M12 Motorway

Amendment Report

October 2020

Figure 4-4 Amended haulage arrangements

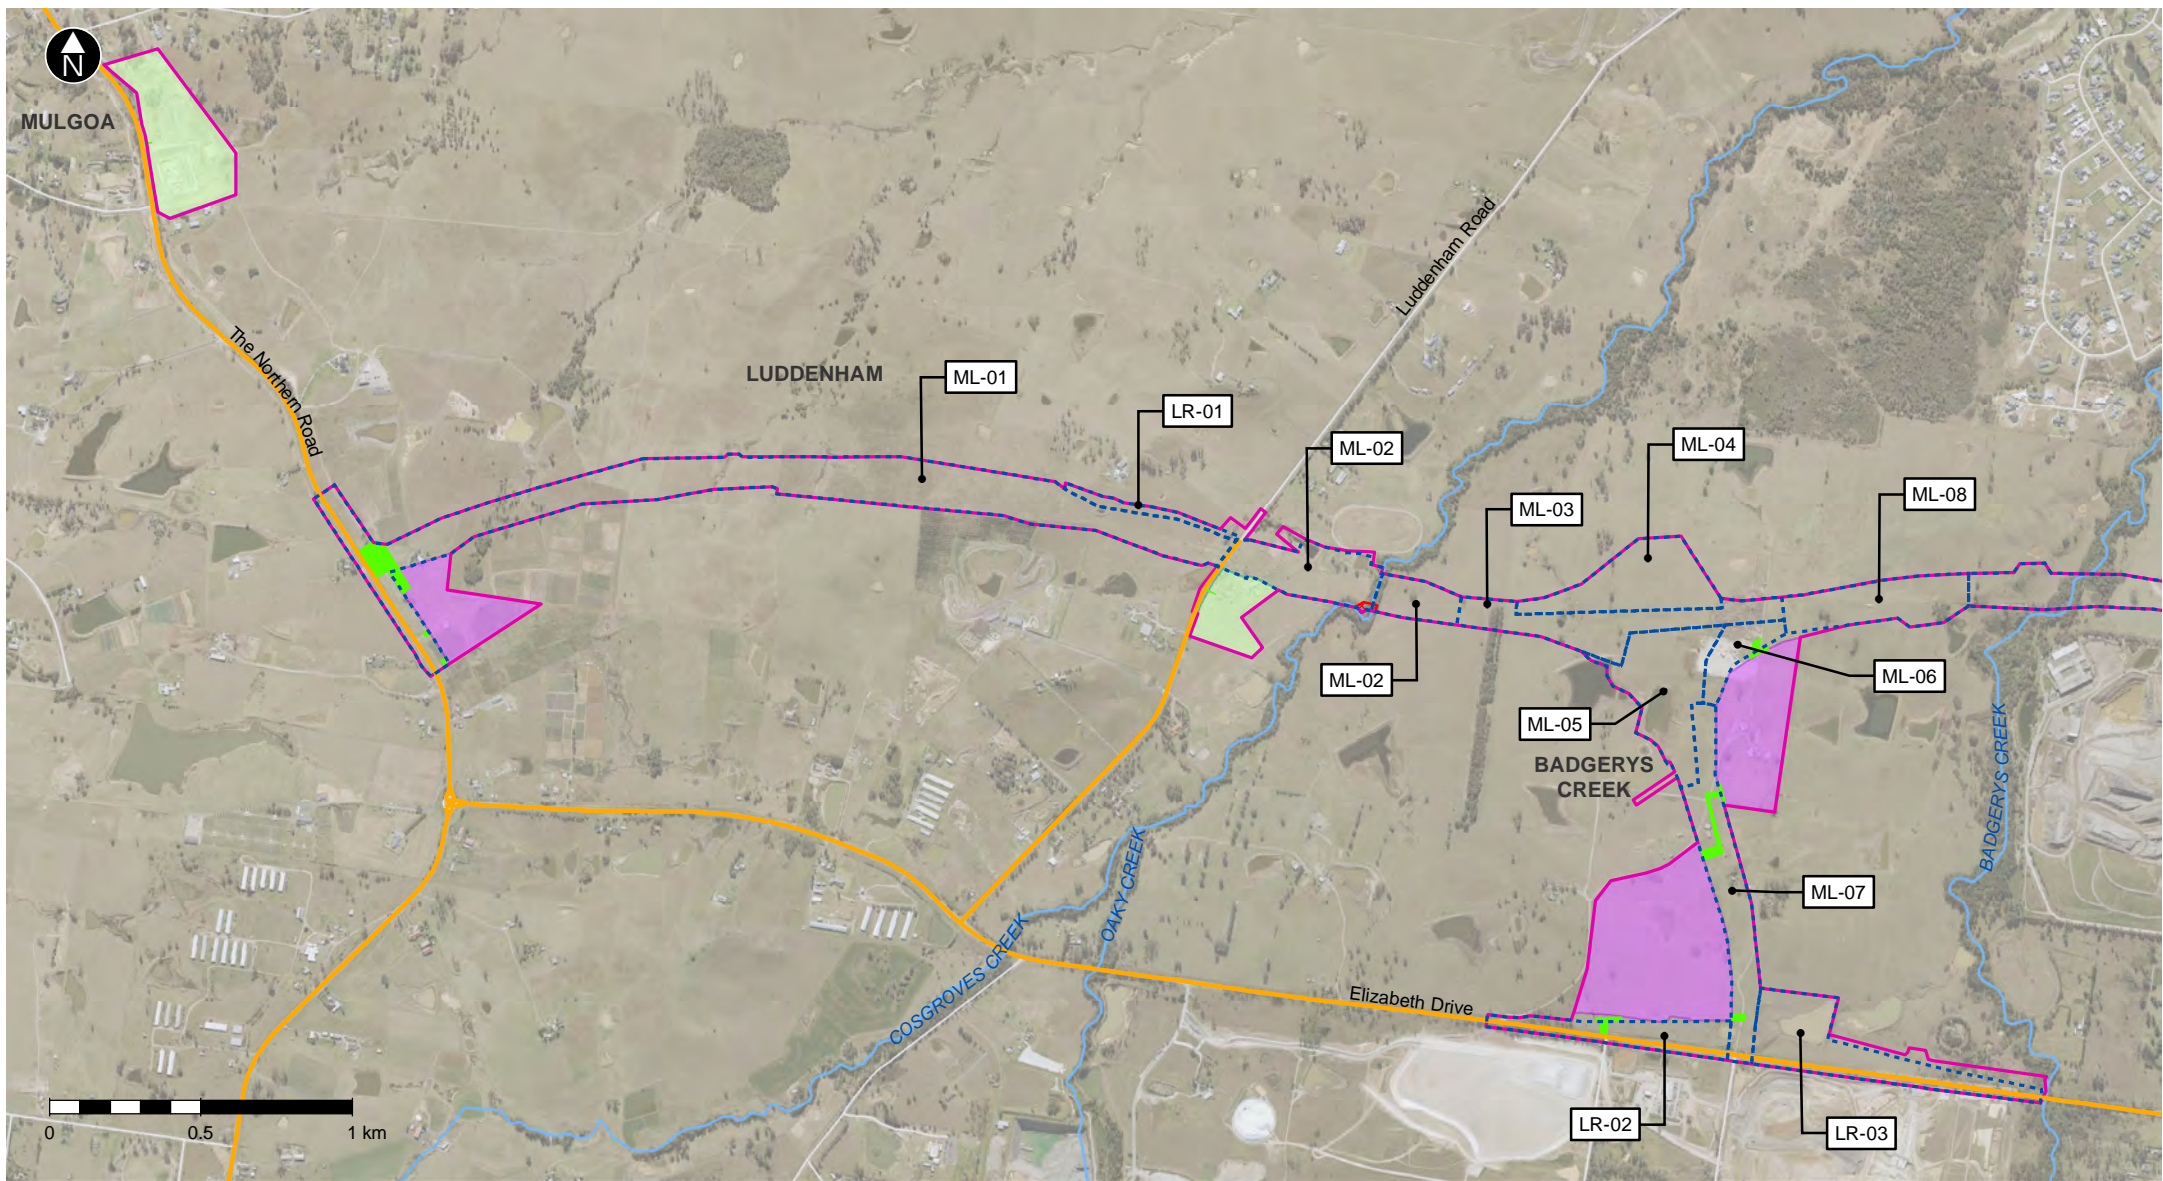
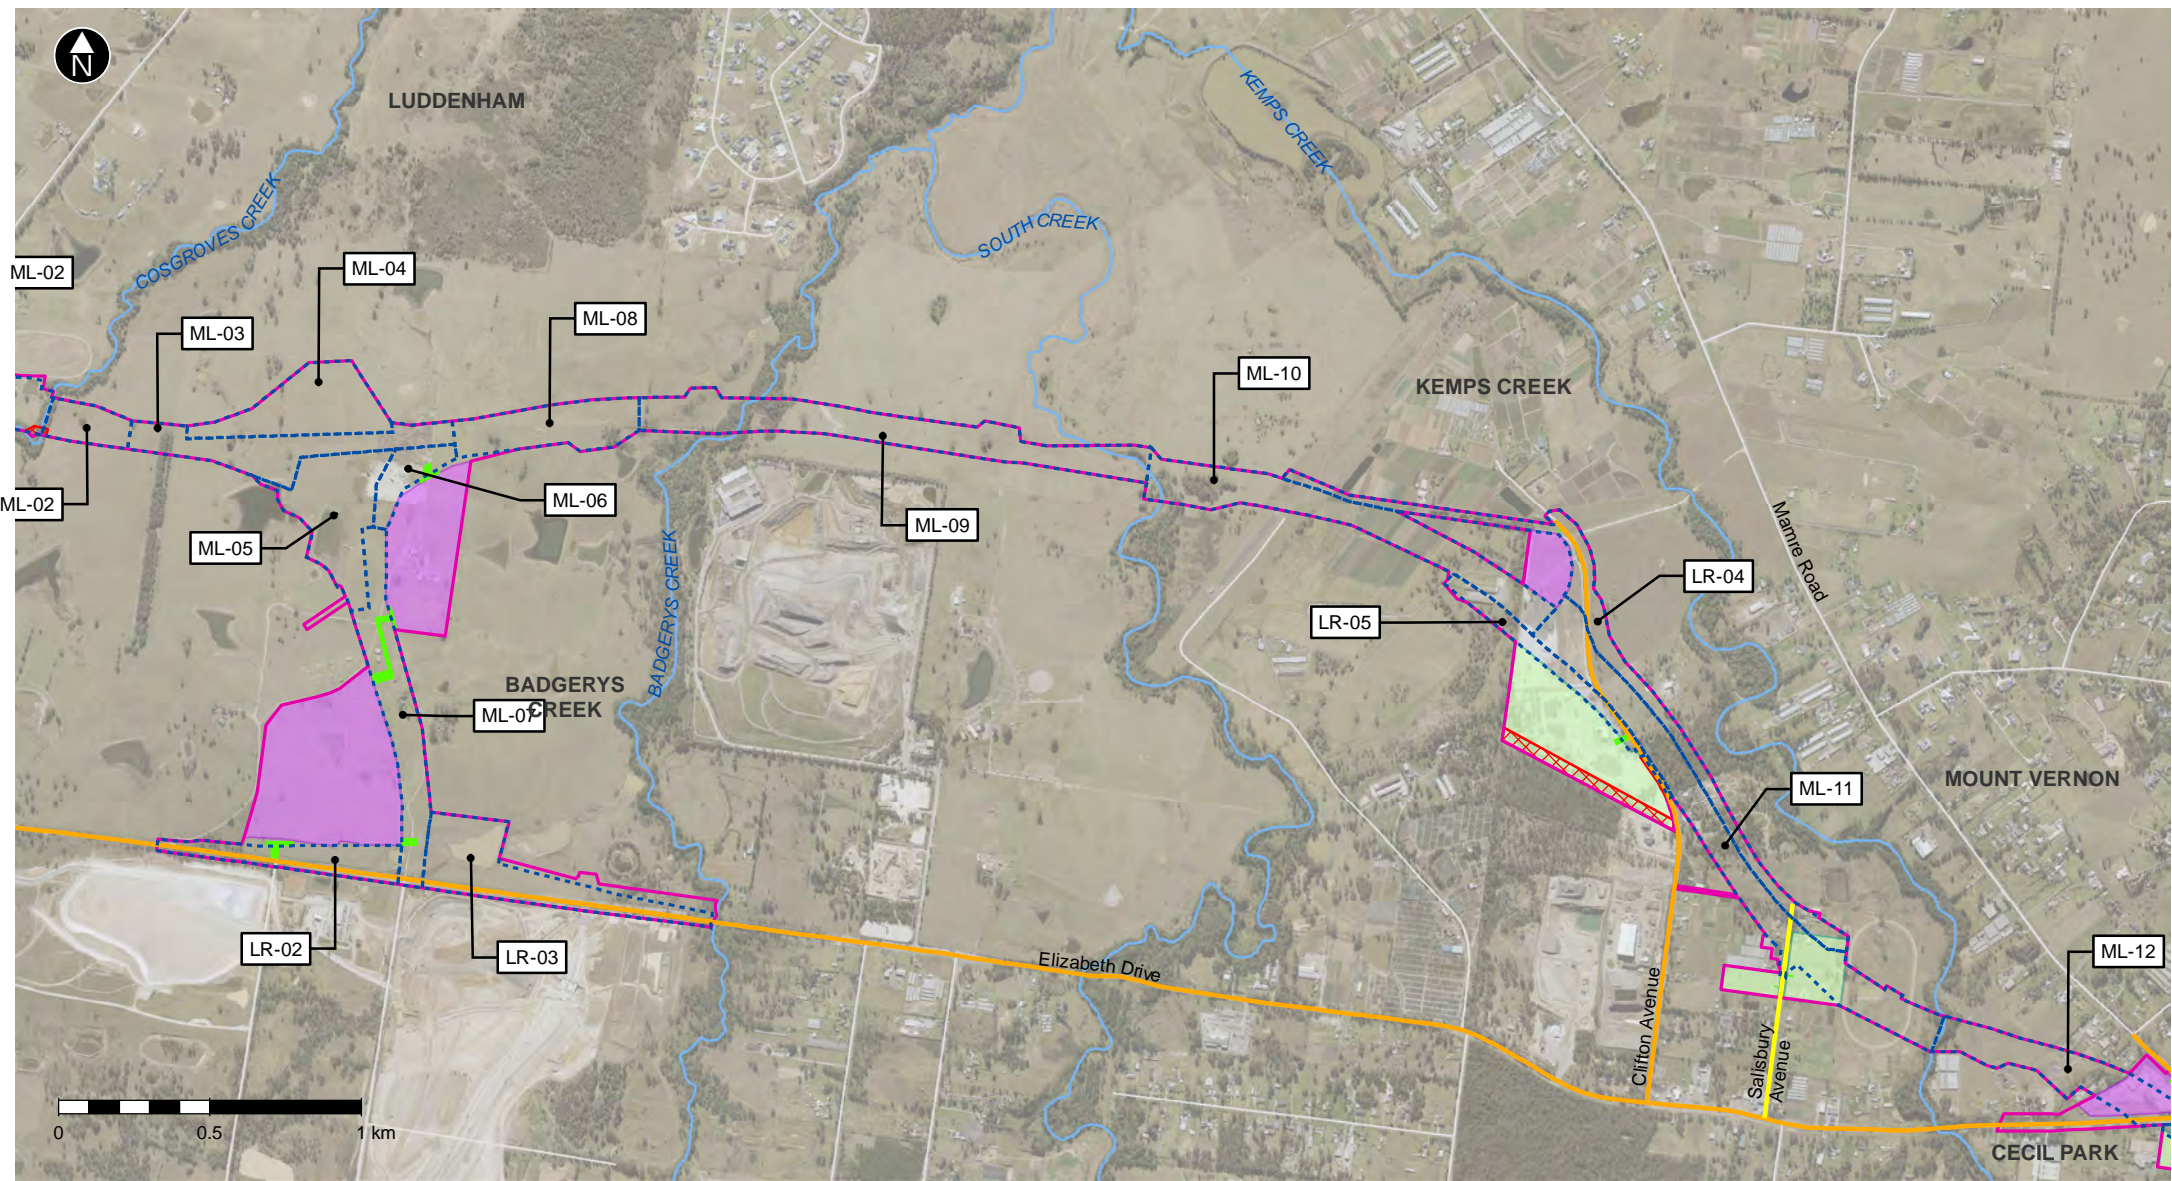
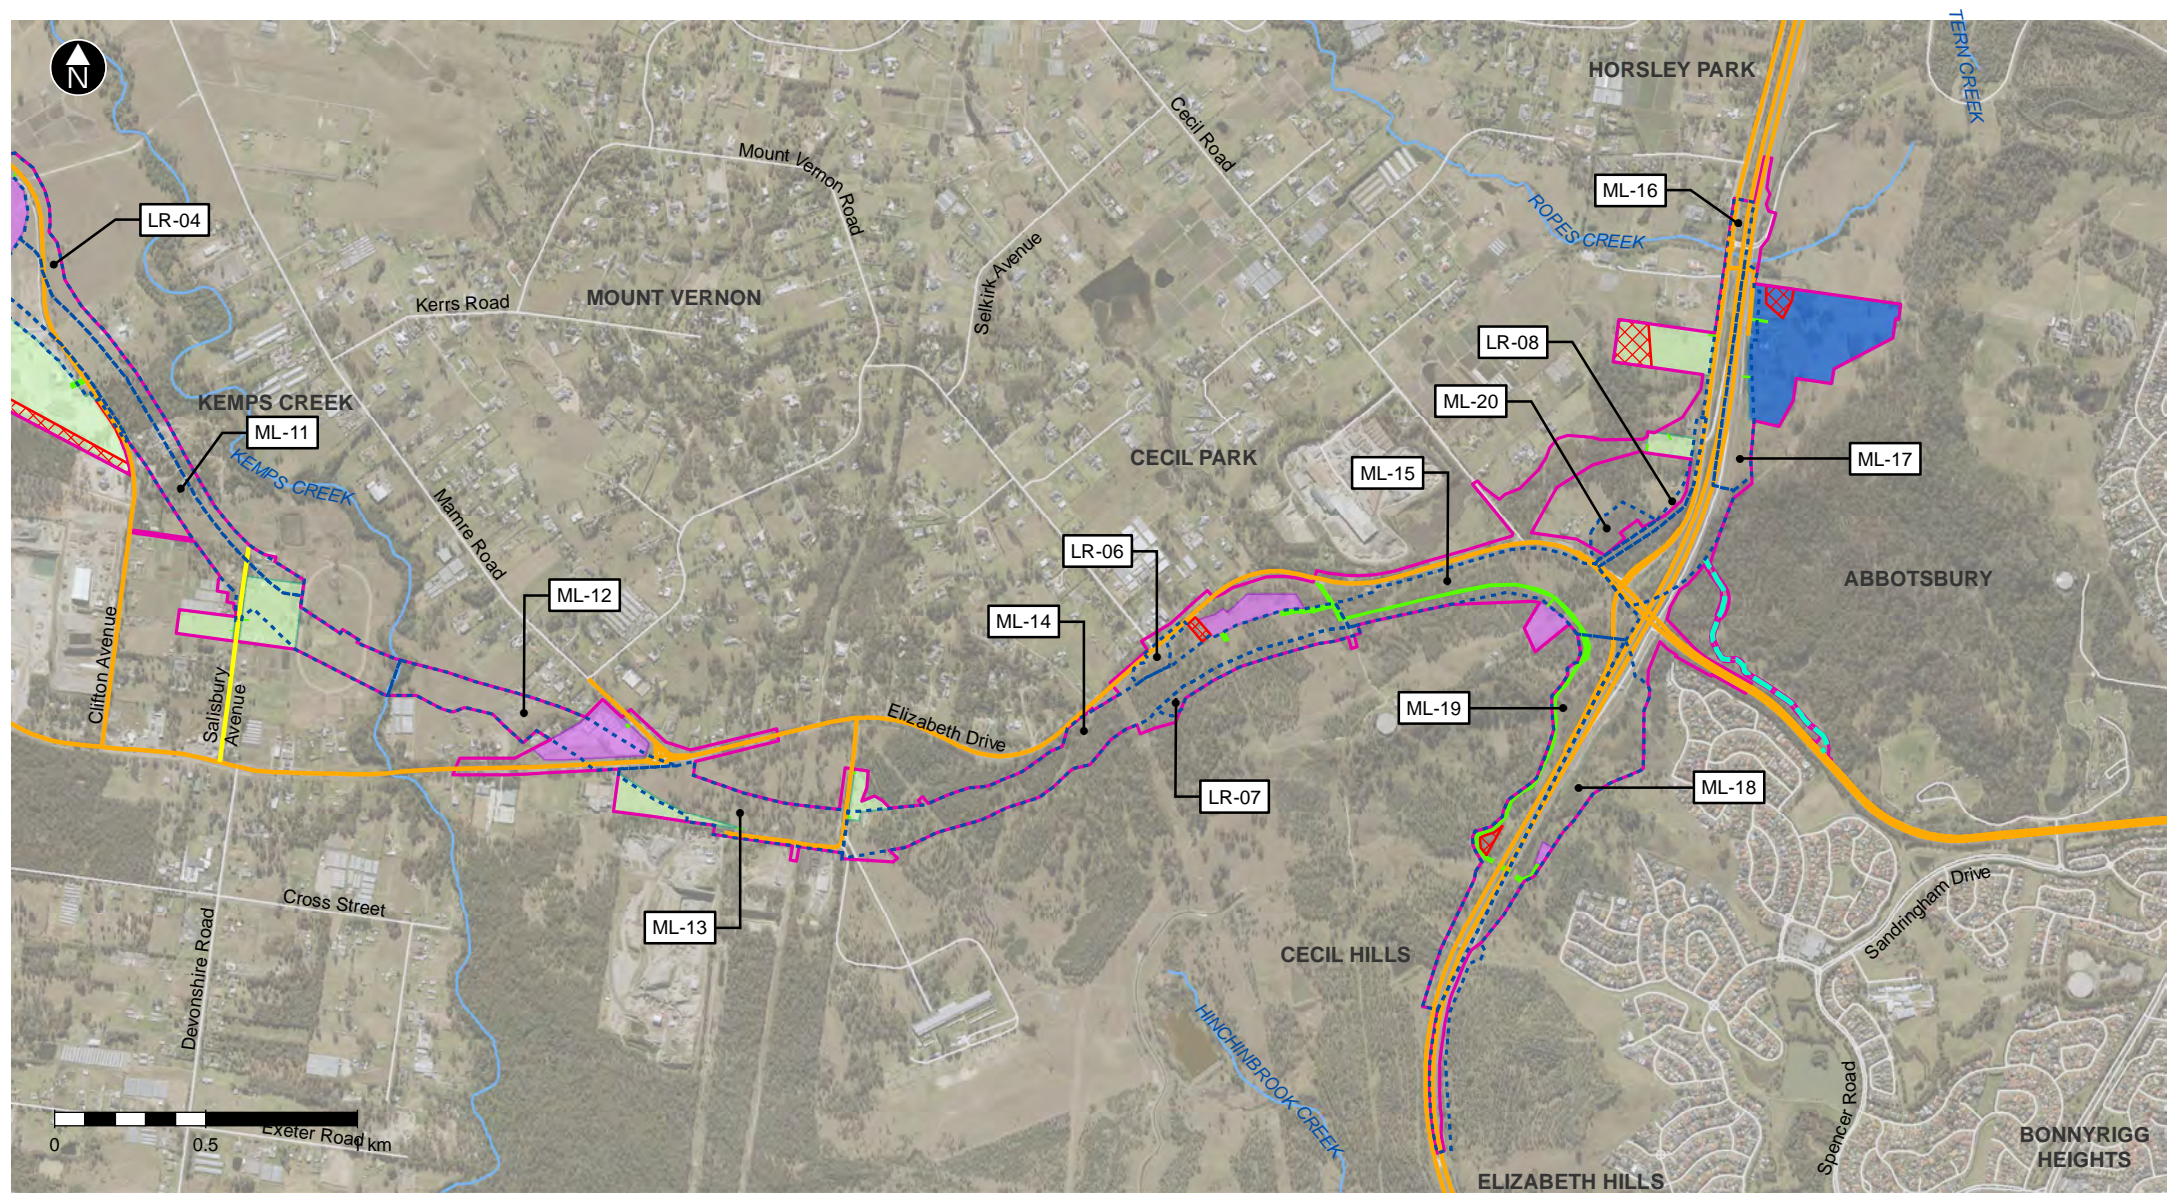
In order to transport materials to the amended construction footprint and access the additional ancillary facilities described in **Section 4.1.2**, three additional haulage routes would be required. These are described in **Table 4-6** and **Figure 4-4**.
